ADDENDUM NO. 1

DATE: December 22, 2014

15-C-00008; Howard F. Curren Denitrification Filter Media Replacement, Phase III

CONTRACT No.	DWG No.	REV.
E34512-M301		C

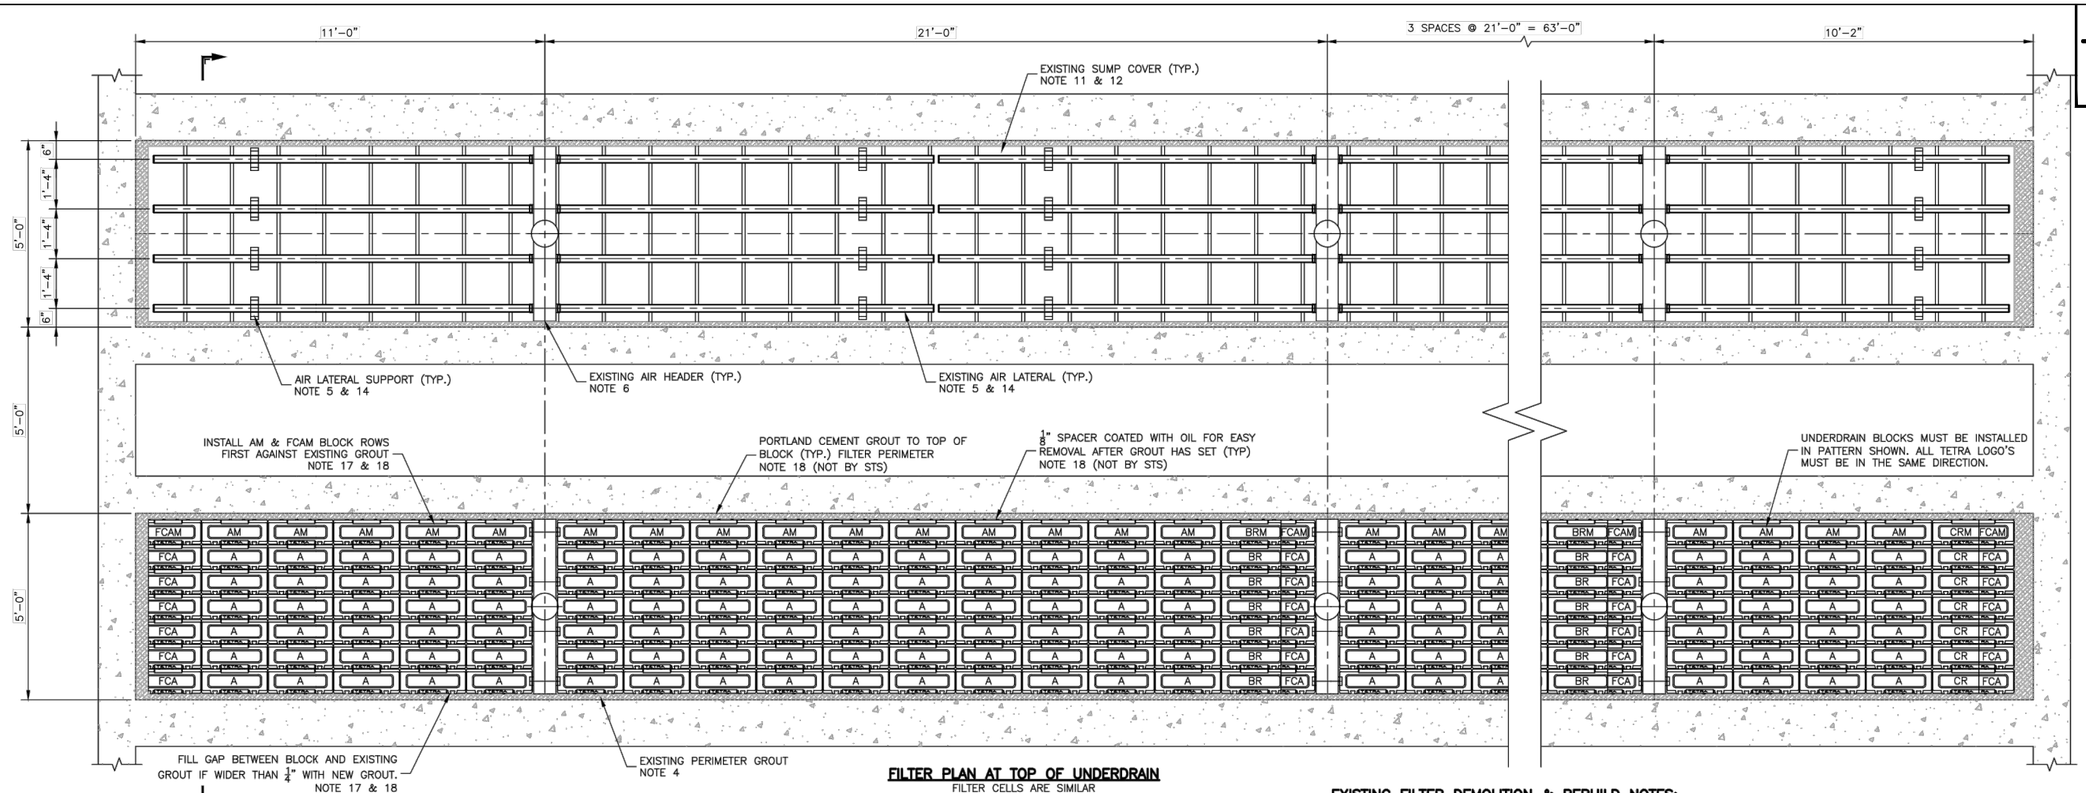
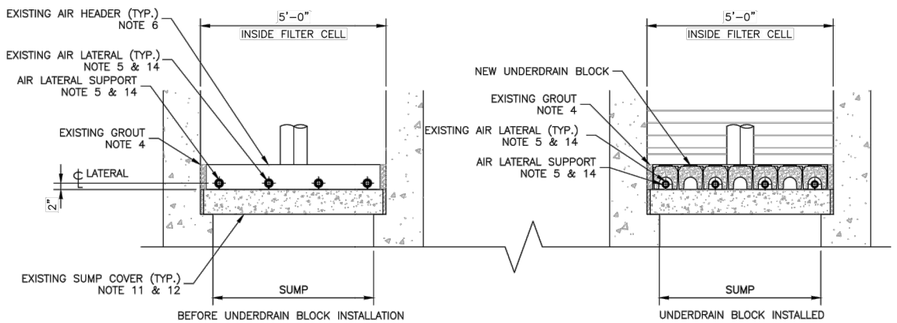
Item 2: Replace plan sheet 3 and plan sheet M301 with the attached revised plan sheets 3 and M301.

1. COMPLETELY DRAIN FILTER.
2. REMOVE ALL OLD MEDIA AND GRAVEL AND DELIVER TO THE CITY.
3. ⚠ REMOVE ALL OLD UNDERDRAIN BLOCK AND DISPOSE OF PROPERLY OFF SITE.

NO.	REVISIONS	BY	DATE	APP'D
⚠	REVISED NOTE 3 BY ADDENDUM		12/18/14
